AST Knitwear Ltd

Plot: 3/1, East Chandon, Joydebpur, Gazipur
(+23.994761N, +90.407653E)

06 October 2013

Building Observations

As built columns at ground level
smaller than shown on permit
drawings

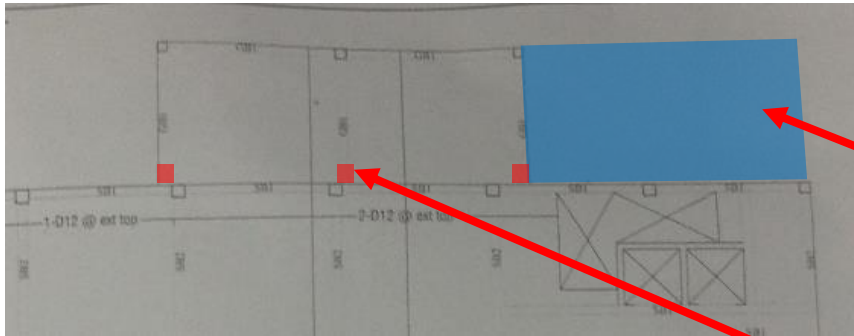
**As built columns at ground level smaller than
shown on permit drawings**

Typical column size
according to drawings:
20" x 20" (500mm x 500mm)

Typical column size as
measured:
15" x 15" (380mm x 380mm)

Create loading plan for all
floors

Provide calculations
showing loading and design
of columns as constructed

**No permit for the additional 3 story annex office building
5 story annex building not built as shown on permit drawings**

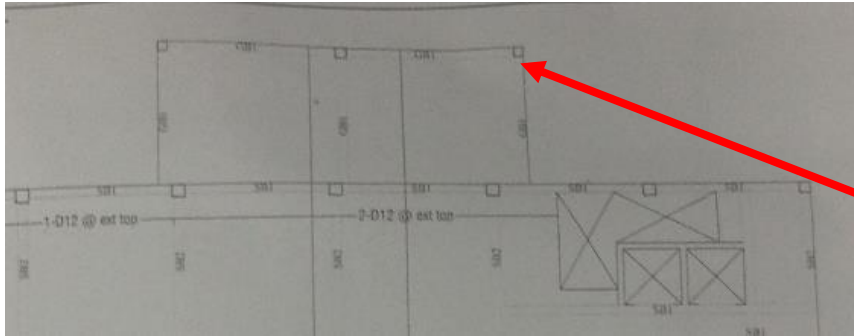
**No permit for the additional 3 story annex office building
5 story annex building not built as shown on permit drawings**

3-Storey Annex not on structural drawings

5-Storey Annex constructed as separate structure, with double column line not shown on permit drawings

Provide calculations showing loading and design of slabs, beams, columns and footings as constructed
